# ***Interactive comment on “Do we (need to) care about canopy radiation schemes in DGVMs? An evaluation and assessment study” by A. Loew et al.***

**A. Loew et al.**

Received and published: 17 December 2013

**Fig. 1.** Dependency of surface albedo difference  $\Delta \alpha$  on LAI for different sun zenith angles

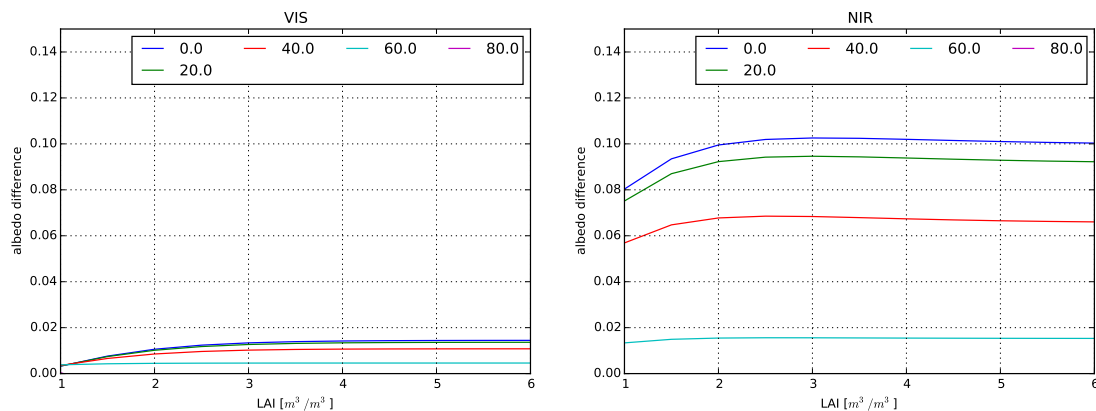
- *In Section 3.1.2, could you explain why the radiative forcing effect increases if the LAI increases?*

The dependency of the radiative forcing of the LAI is dominated by the changes in the reflectance in the NIR domain. Figure 1 shows the difference of surface albedo ( $\Delta\alpha = \alpha_{WSA} - \alpha_{BSA}$ ) for both, the VIS and NIR domain for different solar zenith angles. An increasing LAI leads basically to an increase in  $\Delta\alpha$  between an LAI of 1 and 2.5. Largest increase is observed in the NIR domain.

diffuse and direct surface albedo are important which are increasing both for VIS and NIR (Figure 1). The stronger increase for the NIR comes basically from the different sensitivities of ISO and the direct cases like can be seen from Figure 2.

**We will briefly describe this behavior in a revised version of the manuscript.**
